## V2500-A1/A5 SERIES PROPULSION SYSTEM SERVICE BULLETIN

# V2500-ENG-75-0105

AIR – HP COMPRESSOR STAGE 7 BLEED VALVES – INTRODUCTION OF AN ALTERNATIVE BLEED VALVE  
WITH NEW DESIGN

**POWER PLANT - AIR – BLEED VALVE  
Introduction of Bleed Valve EB101729B  
as an Alternative to Bleed Valve AC69924**

Old Type Bleed Valve p/n AC69924  
Figure 1

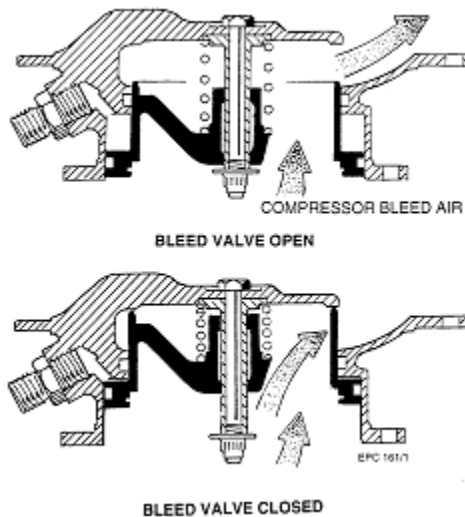
(1) There are no rework procedures introduced by this Service Bulletin. This Service Bulletin introduces the Dunlop HP 7 Bleed Valve p/n EB101729B (Figure 3) as an alternative to the Dunlop Stage 7 Bleed Valve p/n AC69924 (Figure 1).

(a) The new Bleed Valve p/n EB101729B is of the 'Bullet Type' design (Figure 4). It is designed to flow bleed air around the piston and not, in the case of Bleed Valve p/n AC69924 (Figure 2), through the piston. This change in design reduces the entry of bleed air contamination into the Bleed Valve.

New Type Bleed Valve p/n EB101729B

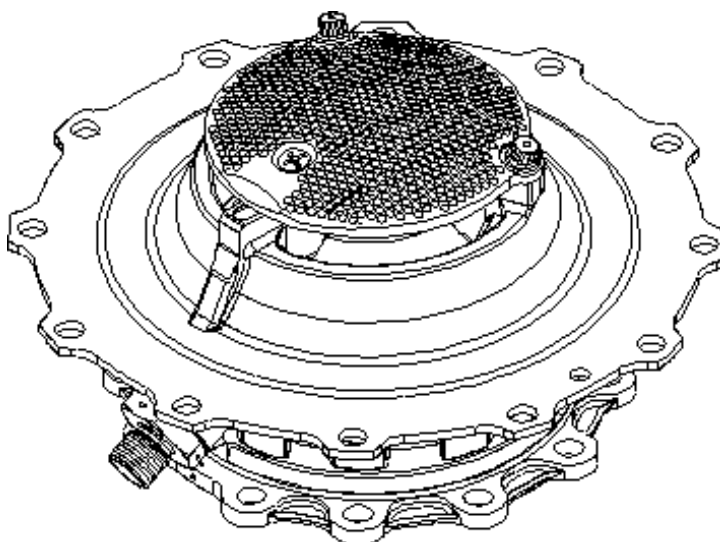
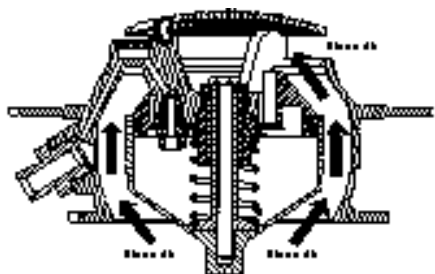
(b) The new Bleed Valve p/n EB101729B has an attached perforated dome plate. The perforated dome plate keeps noise levels within permitted levels.
